# Access Compliance Report Public Rights-of-Way (Curb Ramps)

Main Street: N/A Cross Street: PROSPECT\_ST Location: SE

ADA ID: RPAT211022105723 Ramp Type: Type 6 - Directional 1 Initial Pass/Fail: Pass Overall Compliance: No Severity Score: 4

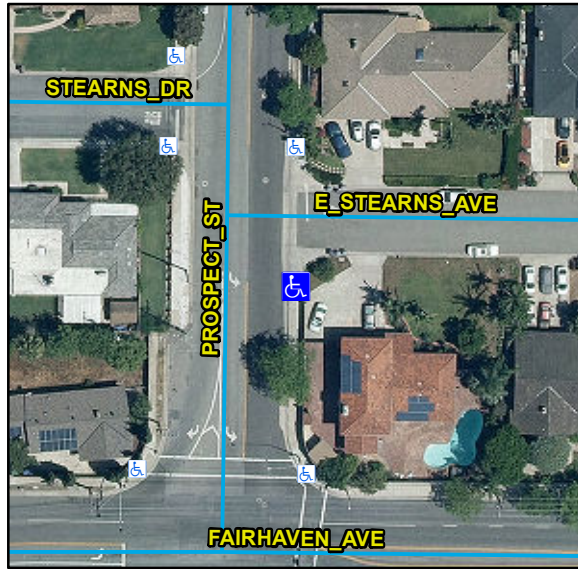
| Compliance | Description                   | Data       | Compliance | Description                   | Data     |
|------------|-------------------------------|------------|------------|-------------------------------|----------|
| No         | Landing Length (in)           | 42         | Yes        | DWS Length (in)               | 36       |
| No         | Landing Cross Slope (%)       | 2.1        | Yes        | DWS Left Offset (in)          | 60       |
| No         | Gutter Cross Slope (%)        | 5          |            | Parallel Ramp Side            | Left     |

Remove & Replace Entire Ramp. Remove & Replace Gutter.

R304.2.1, R304.5.3, R304.2.3, STD 1115
